COMMONWEALTH EDISON COMPANY

LA SALLE COUNTY STATION, UNIT 1

AMENDMENT TO FACILITY OPERATING LICENSE

Amendment No. 18
License No. NPF-11

Figure 3.2.3-1 MINIMUM CRITICAL POWER RATIO (MCPR) VERSUS $1/v$ AT RATED FLOW

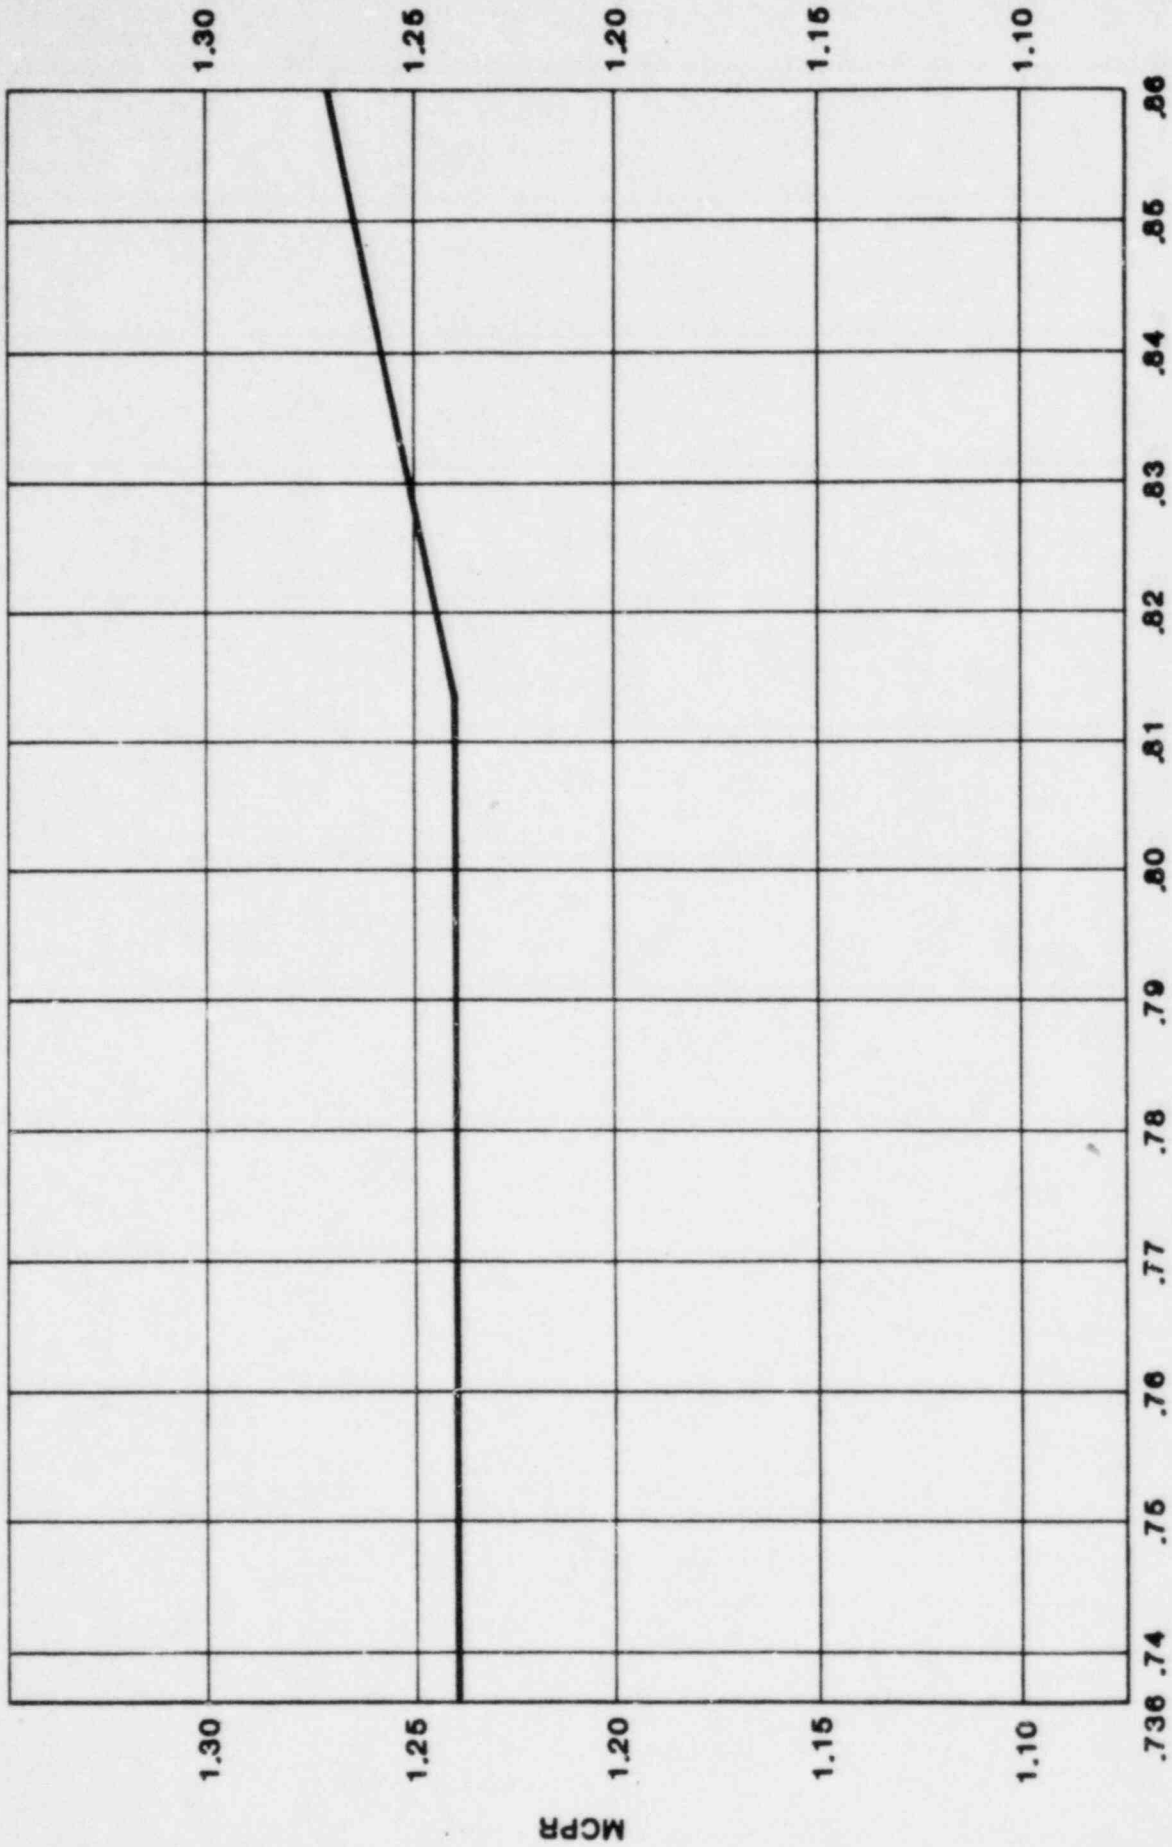
3.2.3 The MINIMUM CRITICAL POWER RATIO (MCPR) shall be equal to or greater than the MCPR limit determined from Figure 3.2.3-1 times the K_f determined from Figure 3.2.3-2 for two recirculation loop operation and shall be equal to or greater than the MCPR limit determined from Figure 3.2.3-1 + 0.01 times the K_f determined from Figure 3.2.3-2 for single recirculation loop operation provided that the end-of-cycle recirculation pump trip (EOC-RPT) system is OPERABLE per Specification 3.3.4.2.

FIGURE 4.7-1

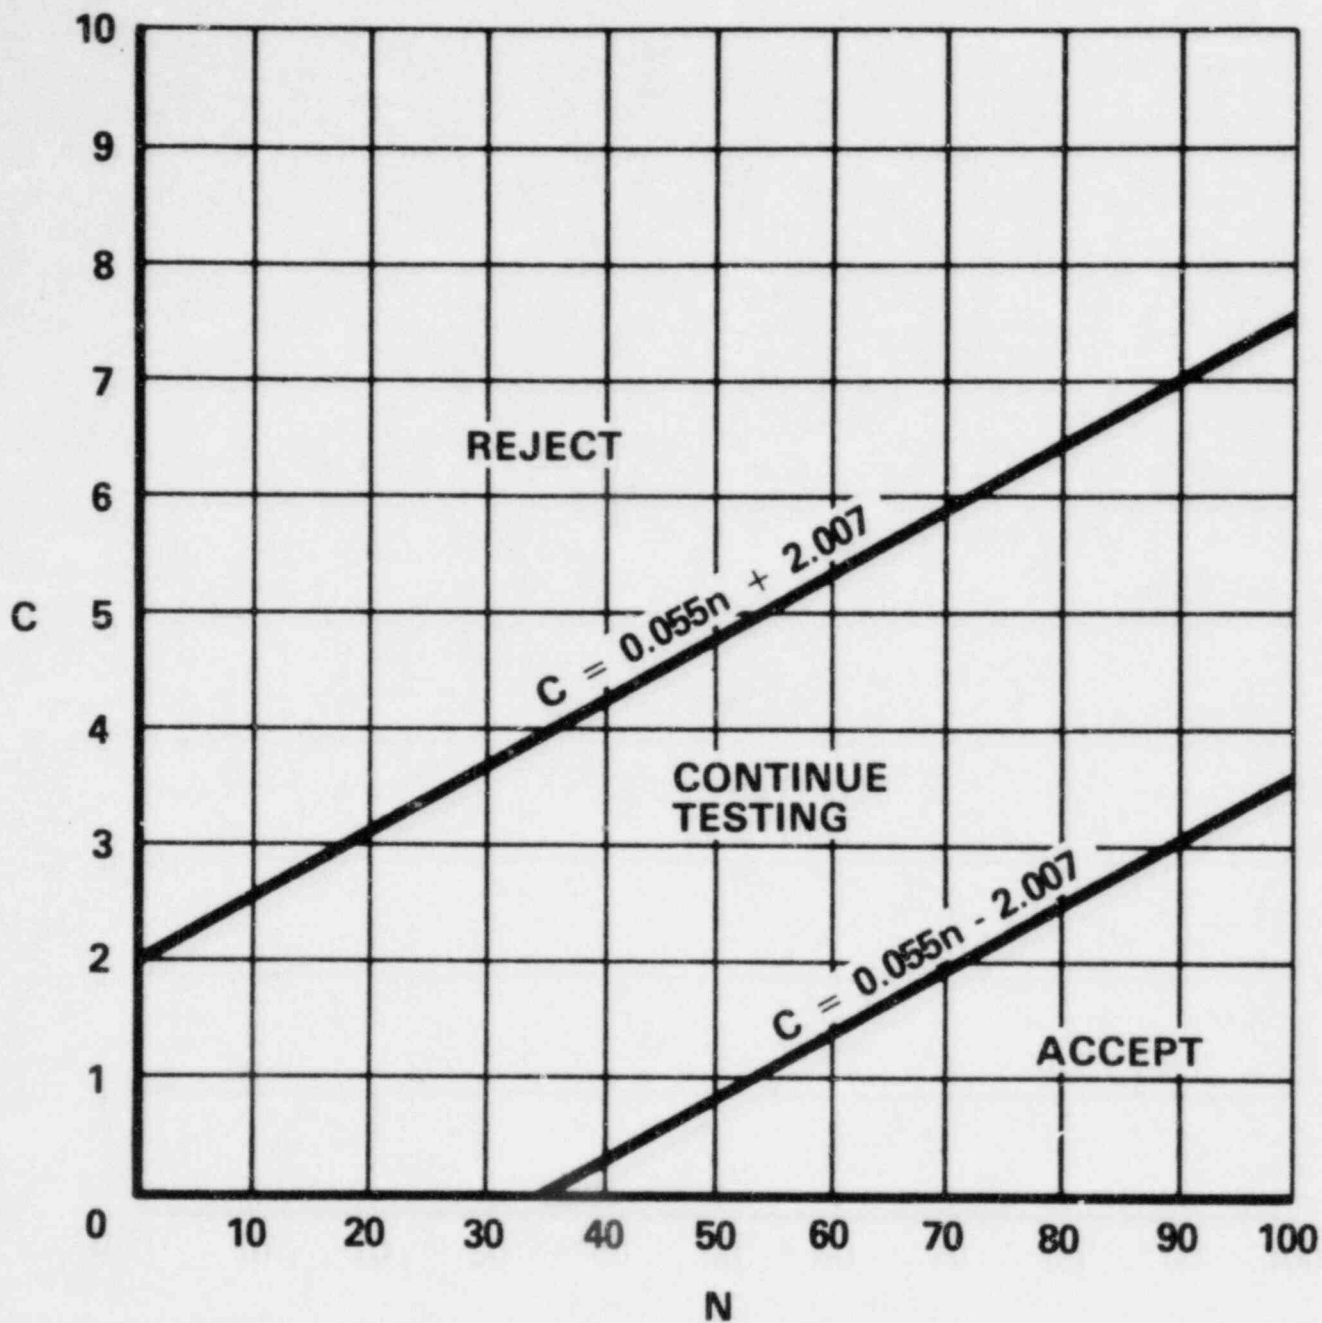
- 1) At least 10% of the total of each type of snubber shall be functionally tested either in-place or in a bench test. For each snubber of a type that does not meet the functional test acceptance criteria of Specification 4.7.9f., an additional 10% of that type of snubber shall be functionally tested until no more failures are found or until all snubbers of that type have been functionally tested; or
- 2) A representative sample of each type of snubber shall be functionally tested, in accordance with Figure 4.7-1. "C" is the
